REMARKS

In response to the Office Action mailed September 14, 2005, Applicants respectfully request reconsideration.

Docket No.: S1022.80316US00
Date: March 14, 2006

Fig 4

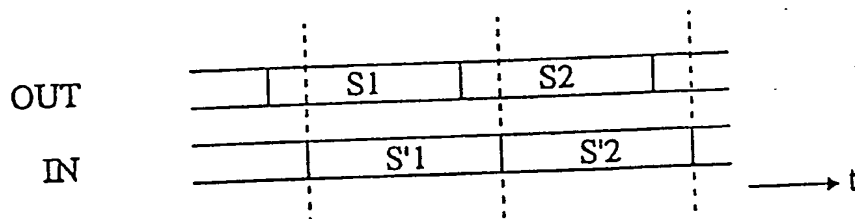
In response to the objections to the text on page 2, lines 23-30, and the objections to the drawings, Applicants have amended Figs. 5, 6 and 8 to alleviate any confusion between use of the term "Sample" and "Symbol." Further, as the amendments to the drawings should further clarify, the dotted lines in Fig. 4 are not representative of the precise point at which a sampling takes place, but rather indicate the boundaries in the time domain between samplings of incoming symbols and outgoing symbols.

Fig. 4 illustrates symbols being transmitted and received in the *time domain*. “For clarity reasons, it is supposed that the incoming symbols convey only one sub-carrier f_1 and the outgoing symbols convey only one sub-carrier f_2 , the sub-carriers f_1 and f_2 being adjacent.” (Page 2, lines 24-26 as amended by this Amendment). In other words, for illustrative purposes, it is supposed that incoming symbols $S'1$ and $S'2$ are composed of only one sub-carrier f_1 , and outgoing symbols $S1$ and $S2$ are composed of only a single sub-carrier f_2 .

As is clearly illustrated in Fig. 4, during the sampling of incoming signal $S'1$, a transition occurs between outgoing symbols $S1$ and $S2$. Accordingly, during the sampling of symbol $S'1$, the *echo* of the transition between the outgoing symbols $S1$ and $S2$ is also sampled. (See page 2, line 26 – page 3, line 2). “Such transitions are discontinuities which have a wide spectrum in the frequency domain. This is shown in figure 3 by dotted lines for sub-carrier f_2 . This wide spectrum effects all the nearby channels.” (Page 3, lines 2-6). Thus, Fig. 3 illustrates that, at the time of the transition between $S1$ and $S2$ in the echo of the outgoing symbol, the discontinuity of the transition causes a wide spectrum, which is illustrated by the dotted lines of sub-carrier f_2 in Fig. 3. The wide spectrum of the discontinuity interferes with the sampling of the symbol $S'1$ on sub-carrier f_1 , which is adjacent to subcarrier f_2 .

Fig 5

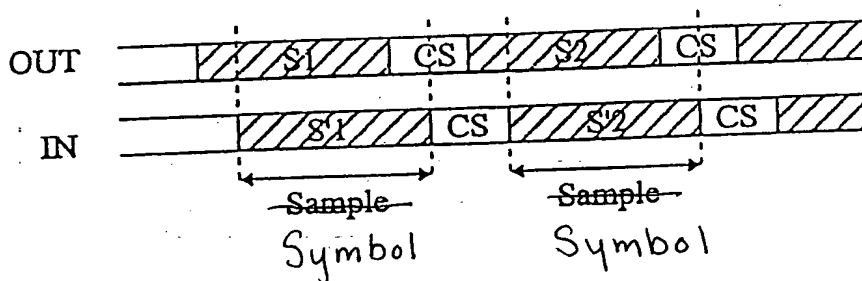
In response to the objections to the drawings (Section 2), Applicants submit herewith Annotated drawings showing the amendments to Figs. 5, 6 and 8, and Replacement Drawings showing Figs. 5, 6 and 8 as amended. Applicants have replaced all occurrences of the term “Sample” with the term “Symbol” in these drawings to be consistent with the specification. No new matter has been added by these changes.

In view of the foregoing, Applicants respectfully request that the changes to Figs. 5, 6 and 8 be accepted and entered, and that the objection to Fig. 5 be withdrawn.

Fig 6

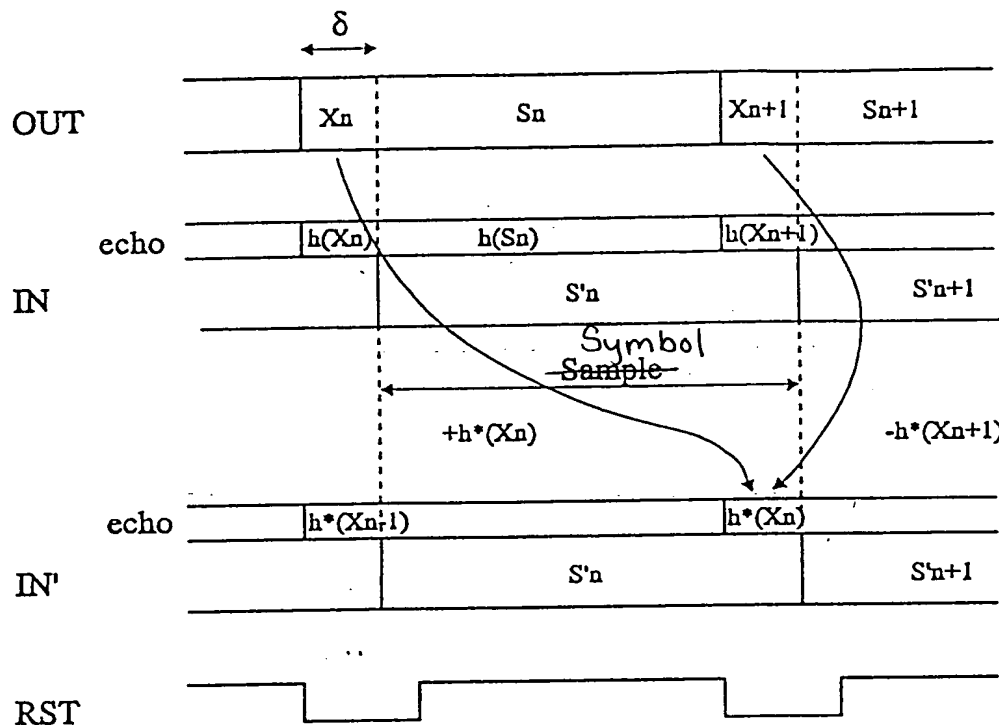
By removing the echo portion and replacing it with a portion from the beginning of the echo symbol S_n , the transition between $h(S_n)$ and $h(X_{n+1})$ of symbol IN illustrated in Fig. 6 is
